Reviewers' comments (Oct. 11th, 2017)

Reviewer #1: Dear Author, please find here a list of comments from my side.

Summary: the article describes the layout, operation and performances of a Radial Time Projection Chamber with the electron amplification stage provided by three layers of GEM. The main novelty is the application of the electron multiplier for the amplification stage in a TPC on a semi-cylindrical shaped plane. The detector, originally built for the BoNuS experiment, is in fact formed by two semi-cylindrically shaped halves connected together, with the axis coincident with the beam line.

Figure 1: The number of active pads versus the measured momentum of the elastic ^4He tracks.

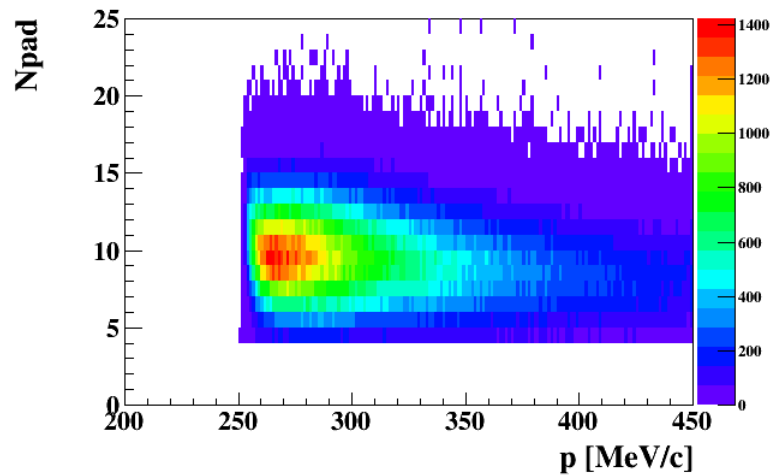
16. Figure 11: I don't understand it. How many tracks does the histo contain? If the single pad has 128 channels, how many channels does the single bin contain? Moreover, is the dE calculated on pad by pad basis? In that case, why don't you put just one point in the histo for each pad? What is the mean number of channels or pads fired by one track? Sorry for the list of questions, but I could not understand the figure.

- It is for only one track (written in the caption). - We don't understand your second question. A pad is a channel. Do you mean how many pads are fired for a single track? Figure ?? shows the number of active pads as a function of the momentum for the collected elastic ^4He tracks.

- dE is calculated from the ADCs of the individual pads that read out hits corresponding to the same track. One needed to know the individual step size very precisely to put dEdx from the individual pads, which is not available. - Last question is addressed by figure ??.

The mean value is around 10 pads.

Figure 2: the number of hits distribution for the collected elastic ^4He tracks from the 1.2 GeV dataset.

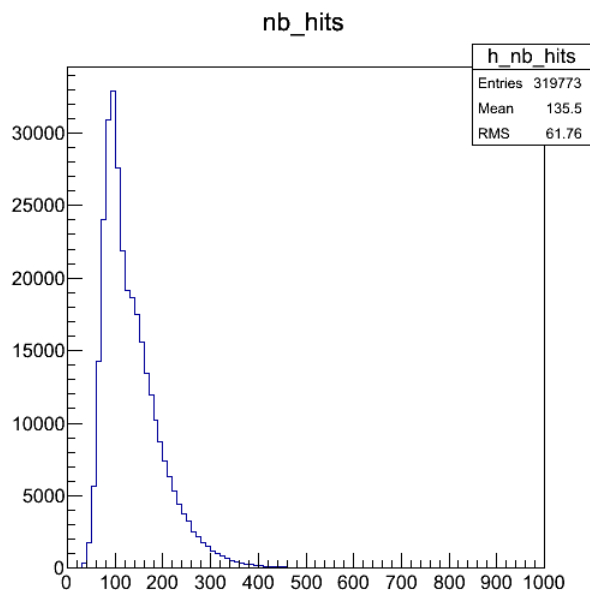
20. How was the "10 hits" cut chosen? What is the mean number of primary ionization in this gas mixture?

Figure 2 shows the number of hits distribution for the collected elastic ^4He tracks from

the 1.2 GeV dataset. The mean number of hits is around 135 and the 10 hits cut at the reconstruction level is a loose cut to reduce the level of the spurious tracks.
